January 25, 2019

**RE: Response to December 21, 2018 MDEP Technical Review Memorandum
New England Clean Energy Connect Project, L-27625-26-A-N**

315641-SW-2 Rev-0.0C

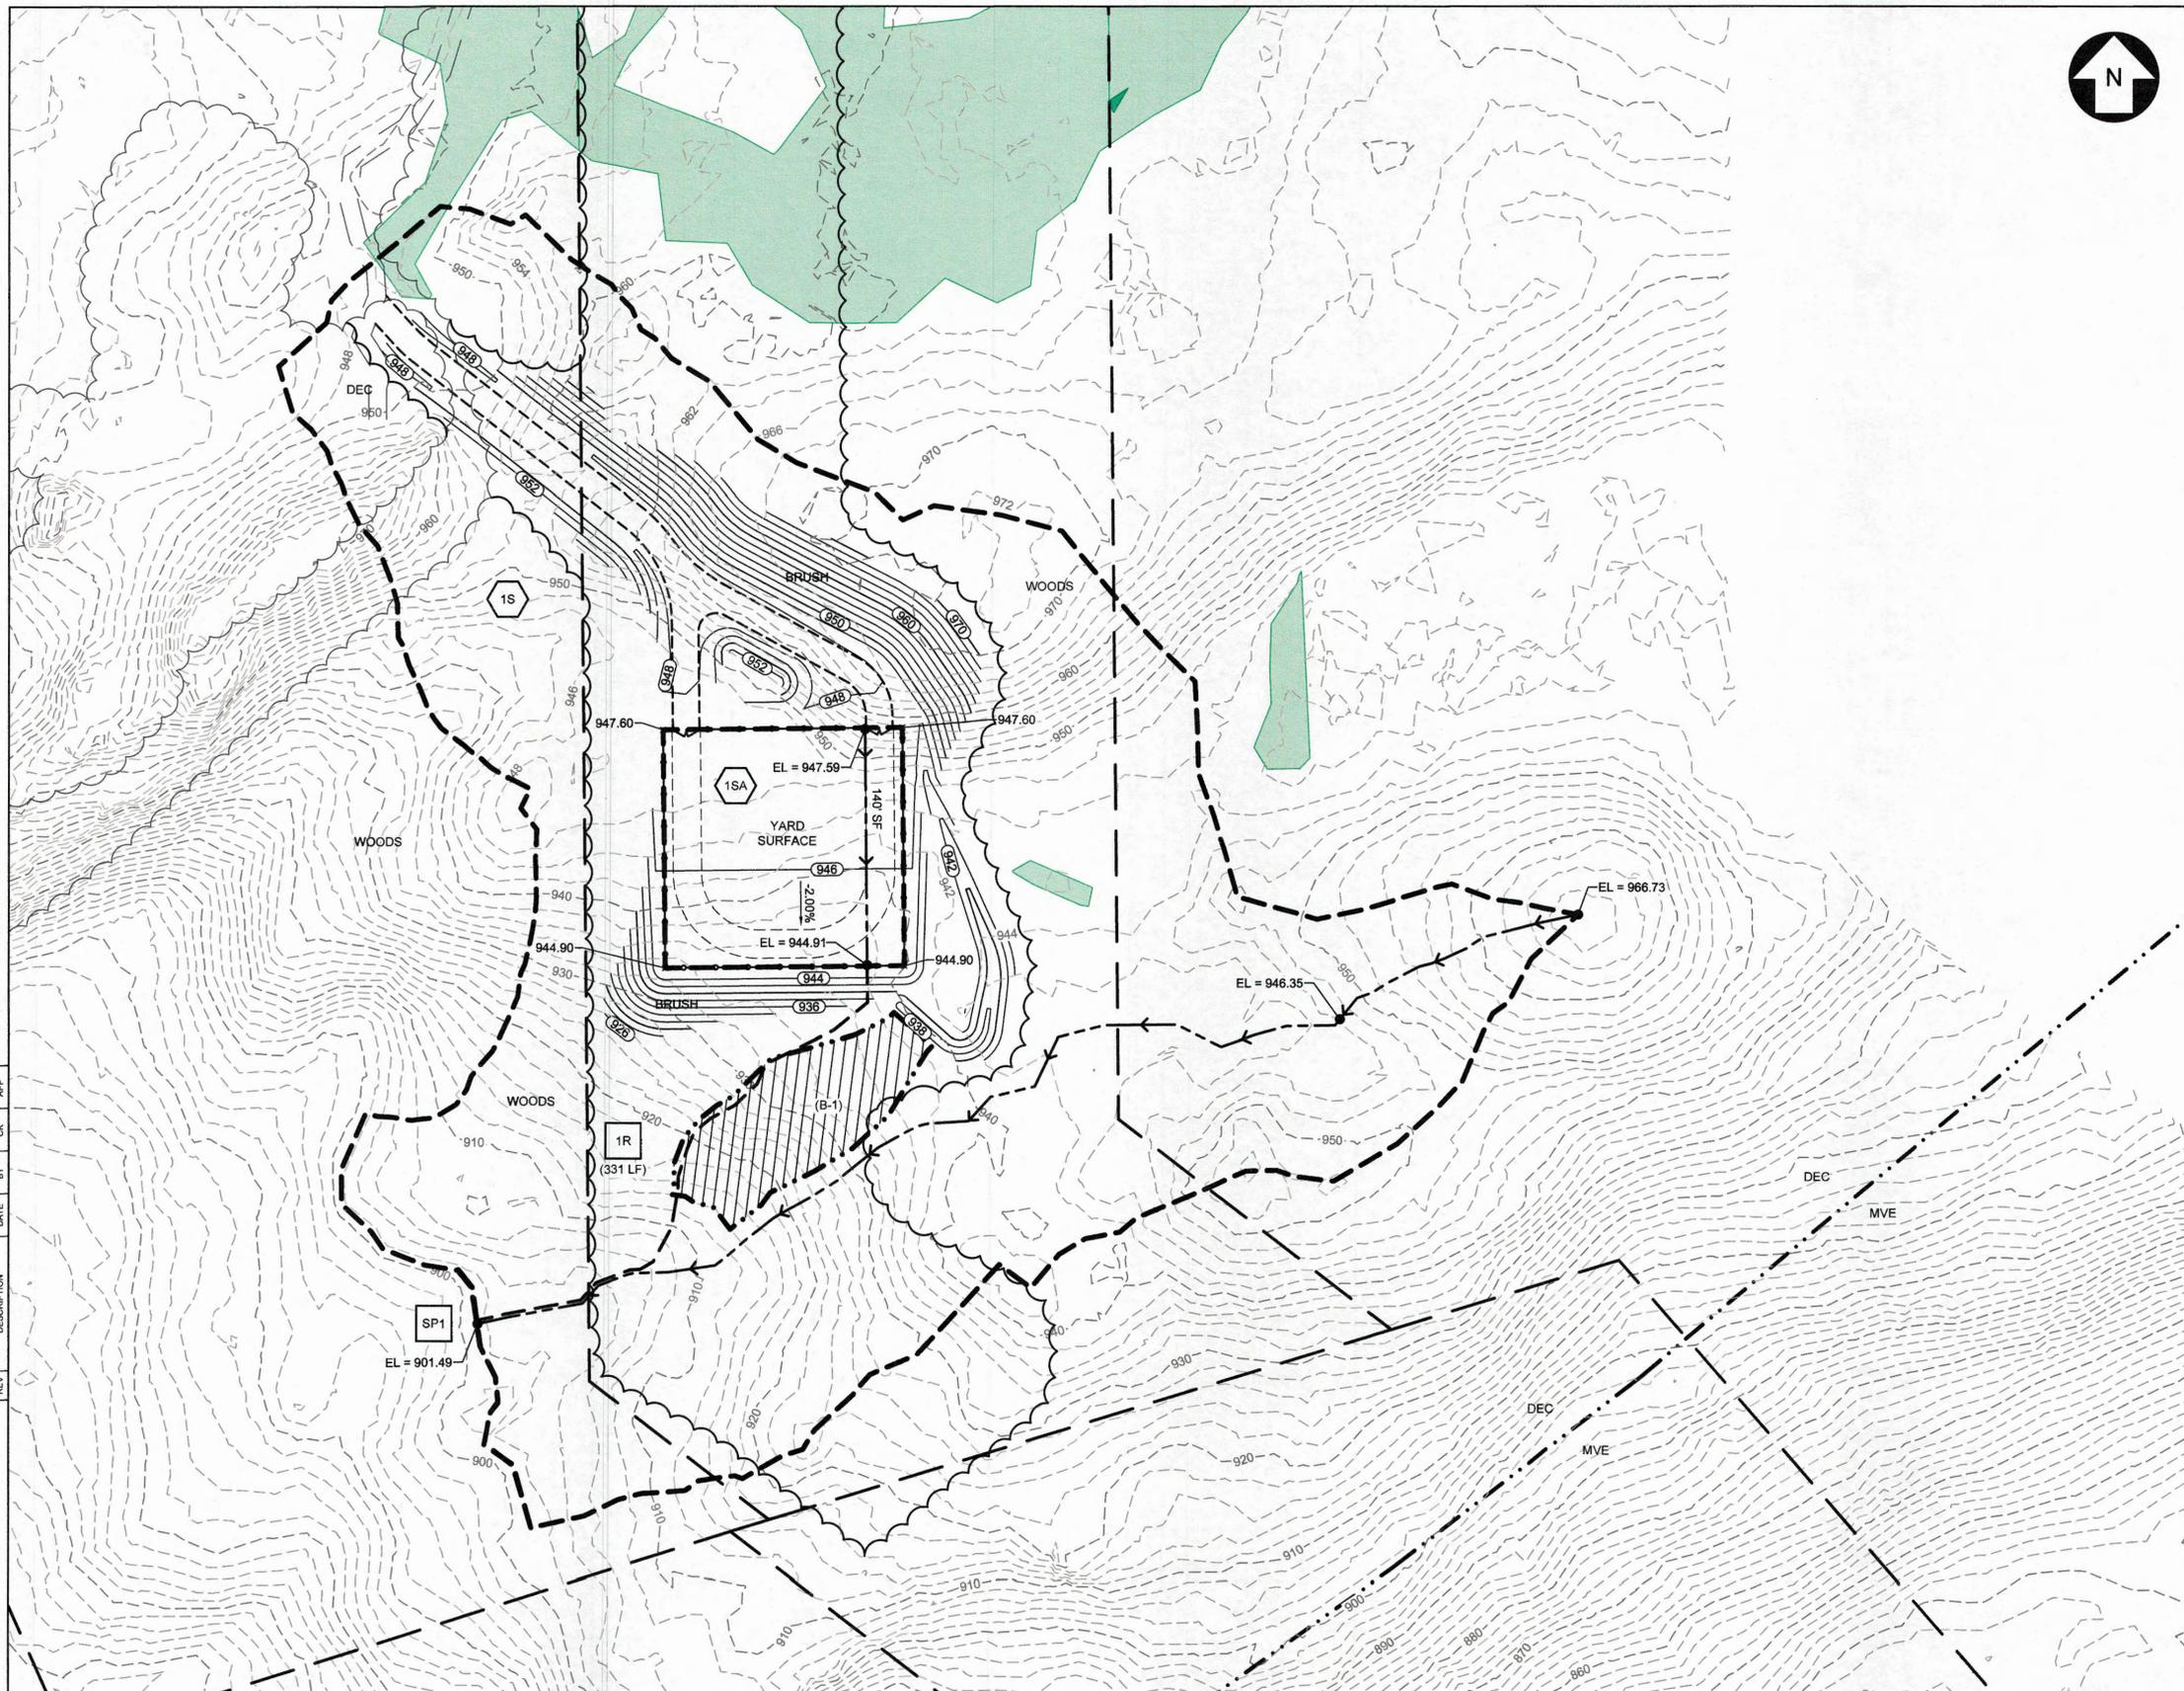
Please provide treatment summary tables for each termination station in the post-development plan sheets (315641 SW-2 & 315641 SW-4).

Treatment summary tables have been added for each termination station. Please refer to sheets 315641 SW-2 Rev 0.0C and 315641 SW-4 Rev 0.0C (Attachment C).

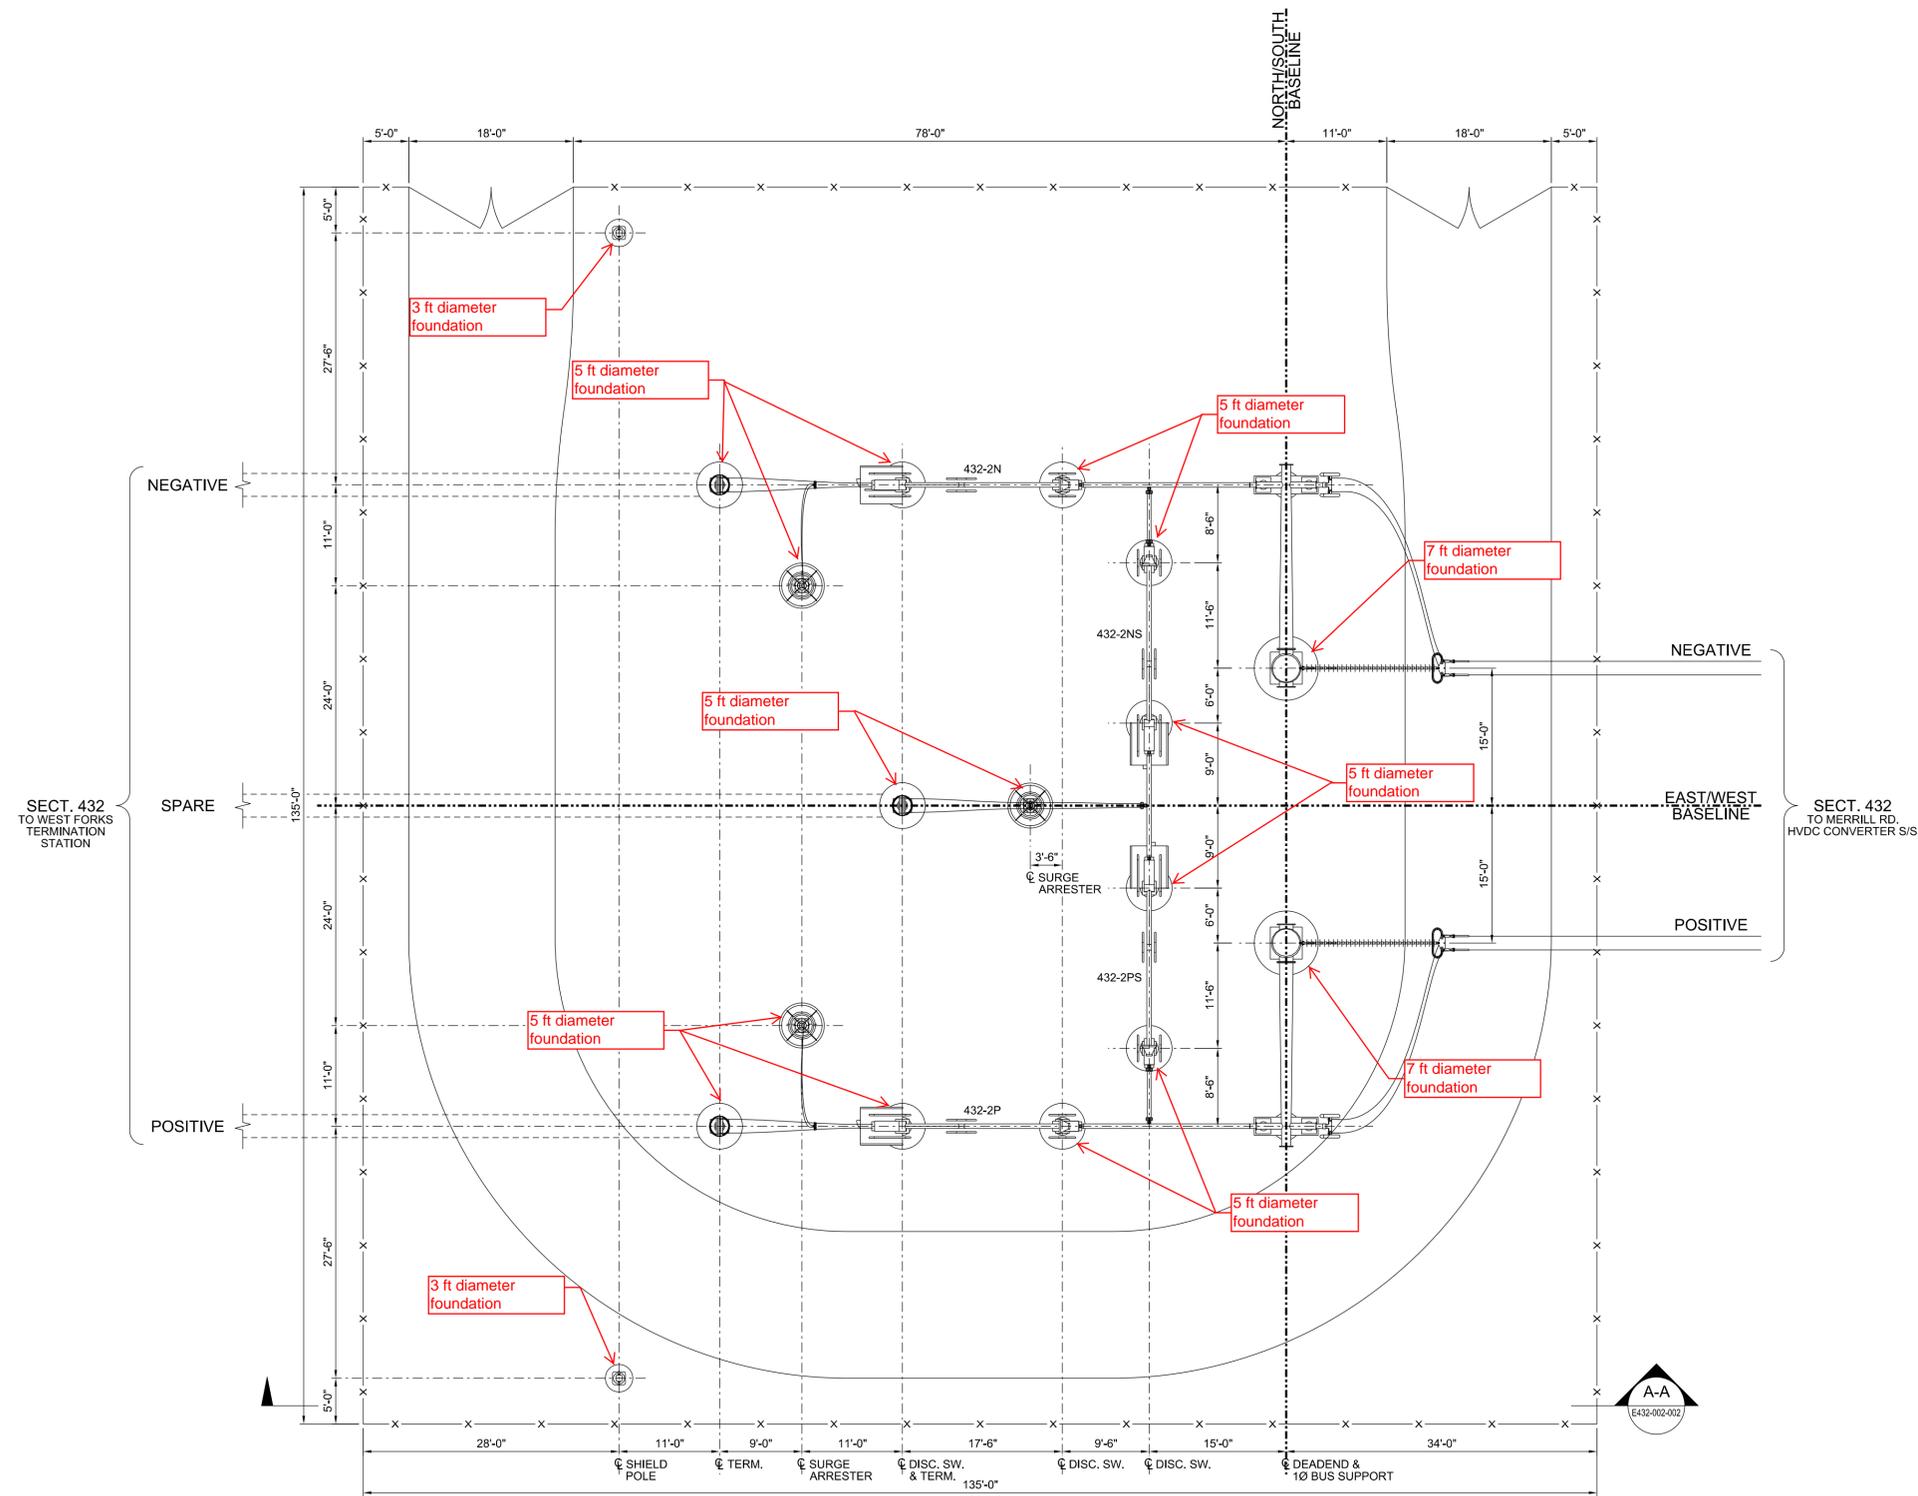
- a. Please confirm that the concrete slabs and similar truly impervious surfaces (curve number = 98) within the termination station yards will not exceed 0.01 ac as given in the post-development HydroCAD models (Subcatchments 1SA and 2SA). If the areas of these surfaces have been revised and increased since the latest submission, please demonstrate that the substation yard will provide minimum one-inch storage for the runoff from the truly impervious surfaces.

The foundation areas are based on the equipment shown on the general arrangement plans for both termination stations. These sketches and calculations are included in the resubmittal package. The total impervious areas for the equipment foundations within each termination station footprint is just under 0.01 acre.

1076-003-002 Sheet 5

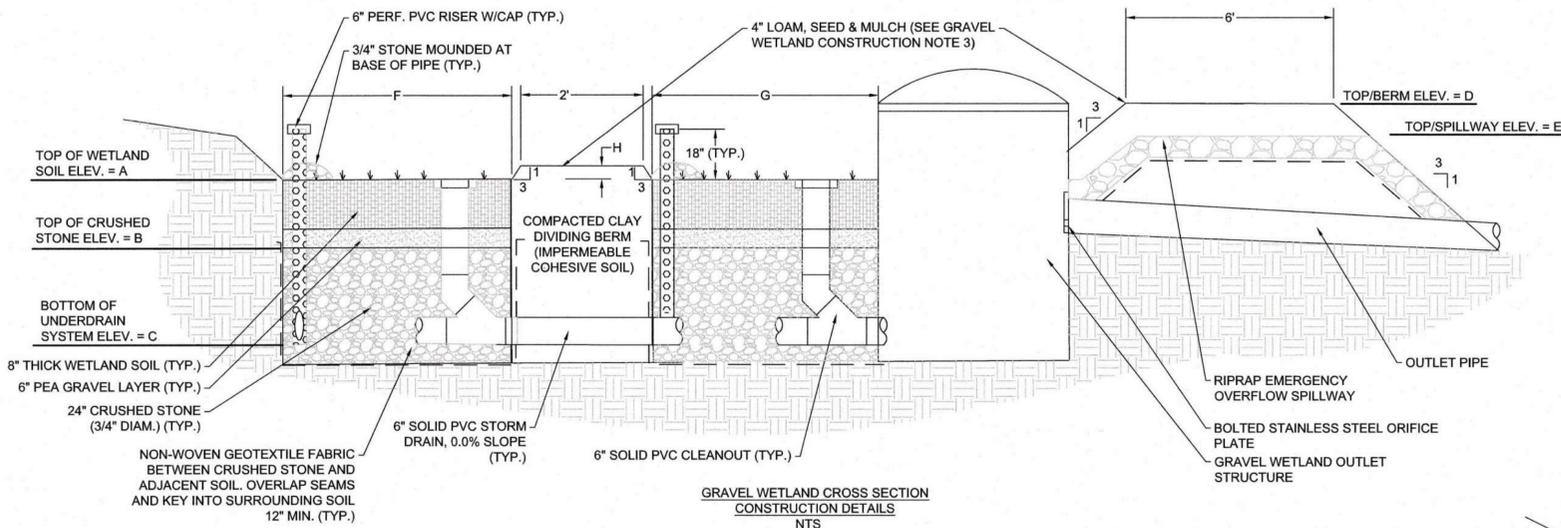
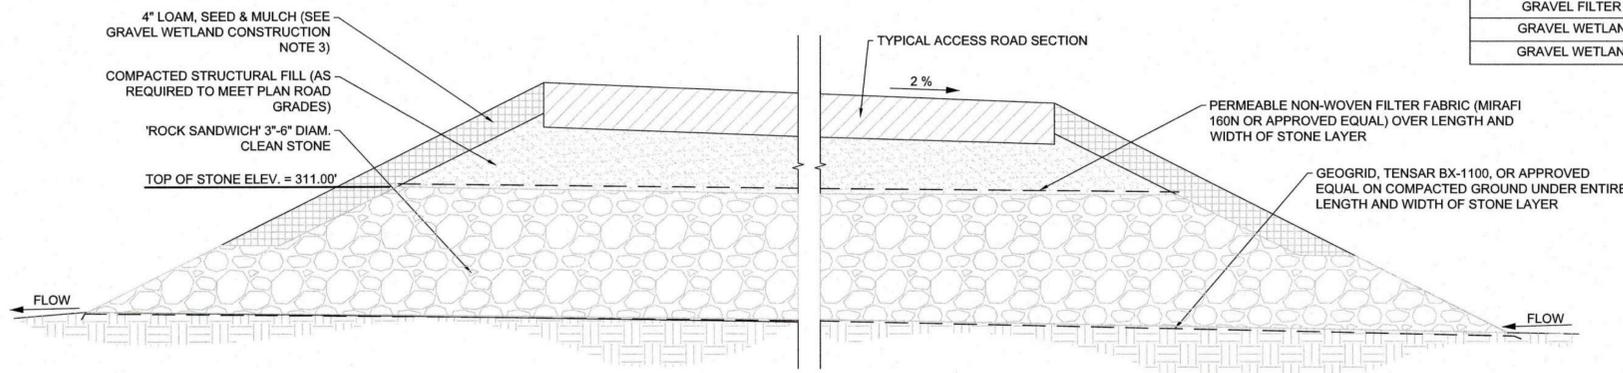
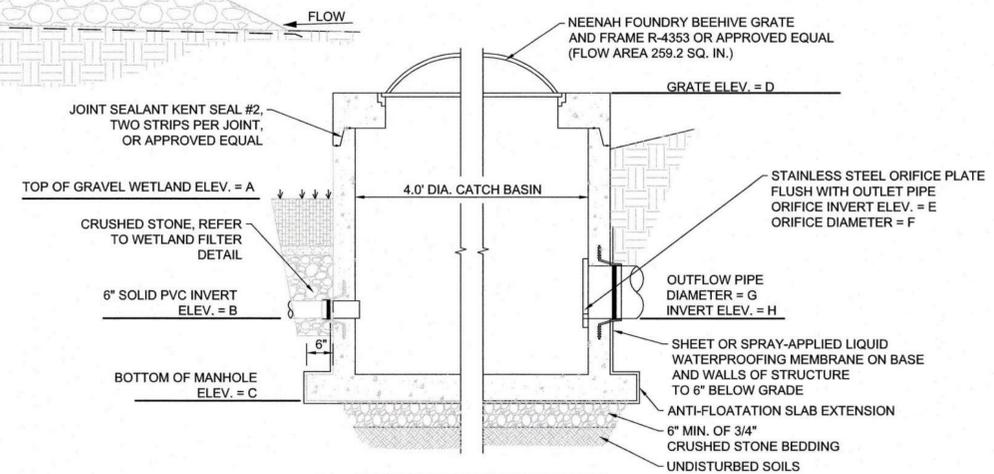
"Gravel Wetland Cross Section Construction Details" & "Gravel Wetland Outlet Control Structure" in 1076-003-002 (Sheet 5 of 6):

- a. The riprap emergency spillway elevations are lower than the outlet control structure (OCS) grate elevations. Please lower the OCS grate elevations to the "top of wetland soil elevation + 1.5 ft",
- b. Clarify the locations of the lateral underdrains in both cells and provide the pipe specifications in the gravel wetland cross sectional details.

The locations of the lateral underdrains in both cells and the pipe specifications in the gravel wetland cross sectional details are provided in 1076-003-002 (Stormwater Treatment Plan Sheet 5 of 6). See Attachment E.
